CITY CENTRE TO TOLLBAR END CYCLEWAY REPORT

Methodology

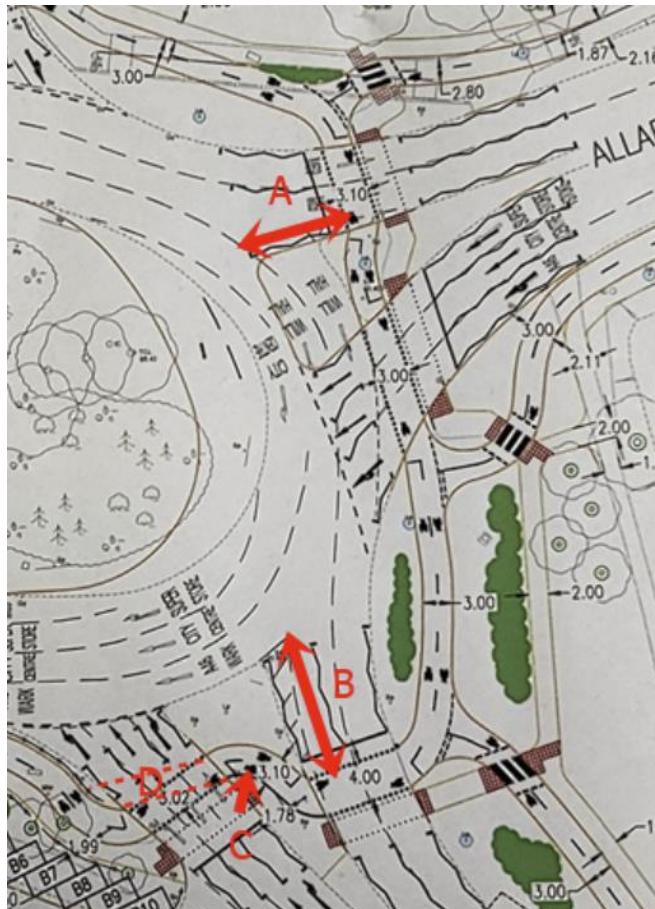
5 Proposed new slip road into ASDA from the London Road will mean trees & green space being lost. Residents asked what volume of traffic would use this, as it would be an expensive project for perhaps limited gain

10 Allard Way and London Road south junctions.

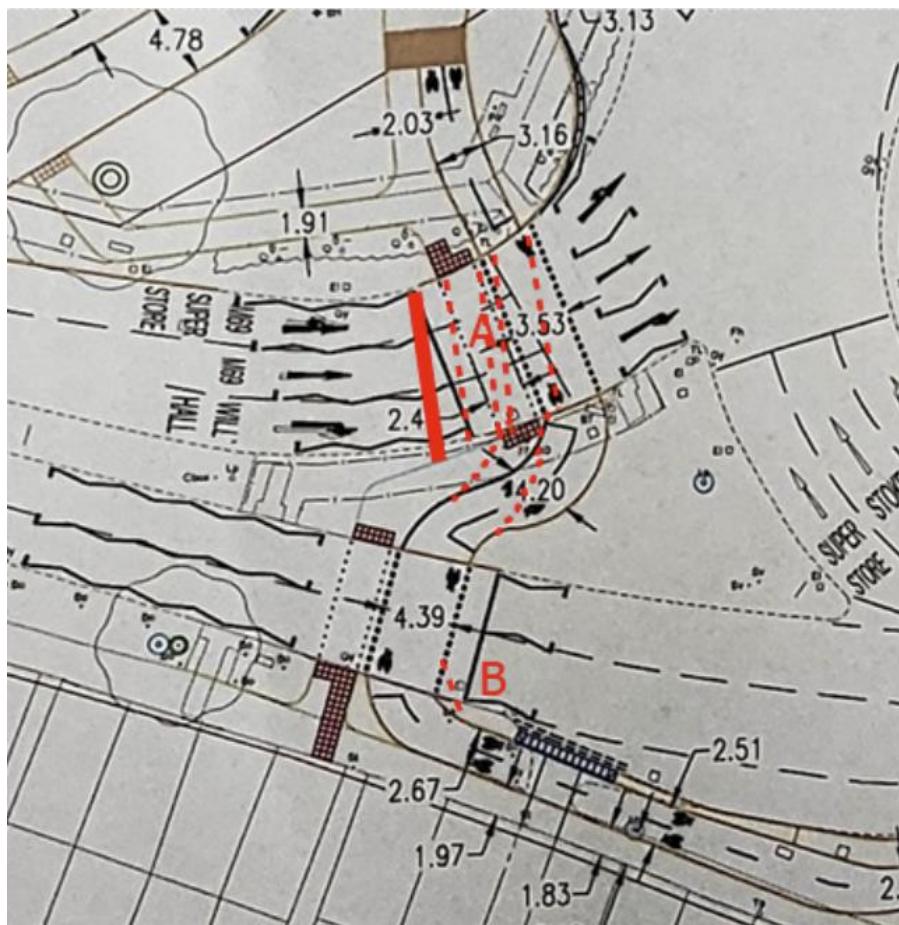
What is the distance of "A" in the above sketch

What is the distance of "B" in the above sketch

Could B be reduced to length A or even less

What is the minimum radius at "C" in the above sketch

Could the cycleway "D" cross the road at an angle to make it cyclist friendly

11 London Road north junction

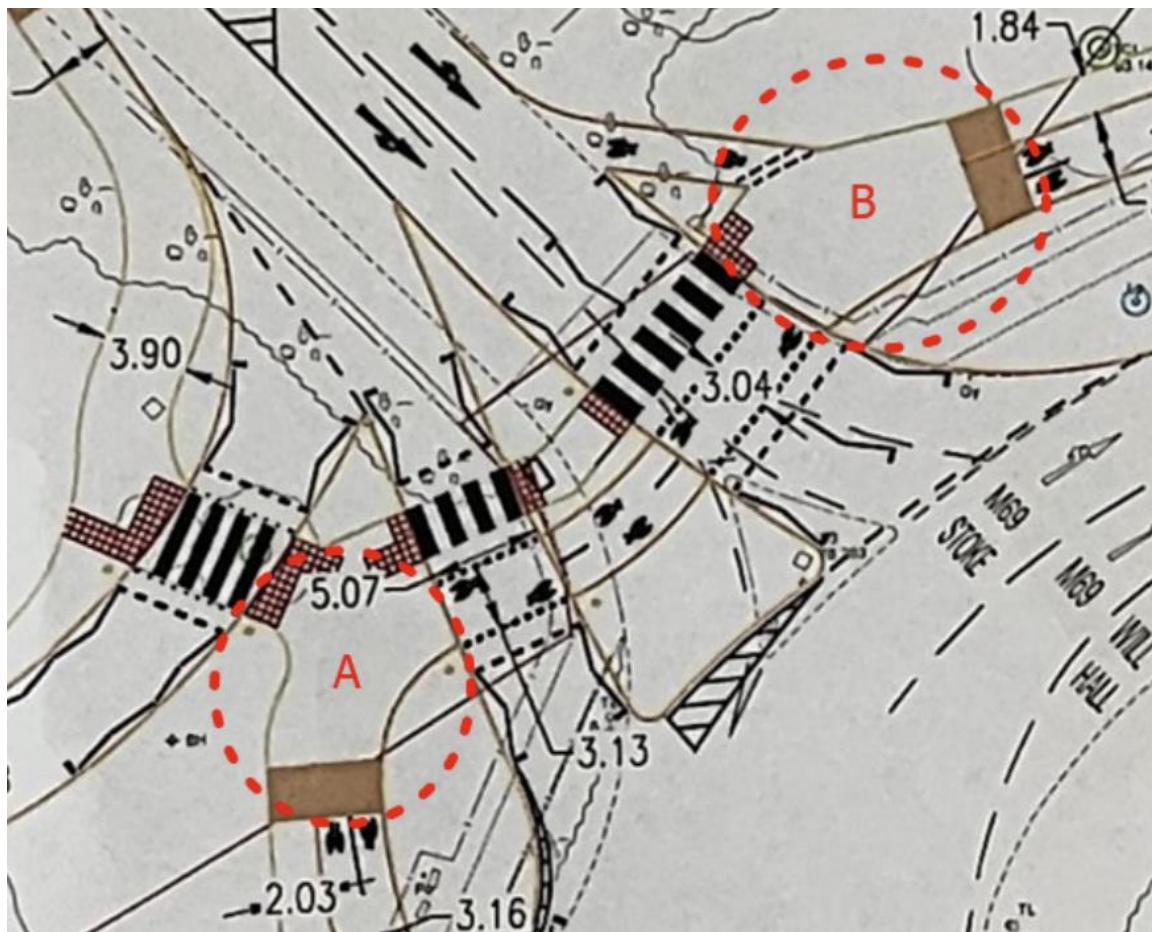
At "A" above, what is to stop the traffic stop line, pedestrian and cycle crossing being angled to make it more cycle friendly. Also it would be safer as there would less risk of cyclists cutting the corner by crossing the pedestrian route.

At "B" above, could the cycle lane be bell mouthed to make it more cycle friendly
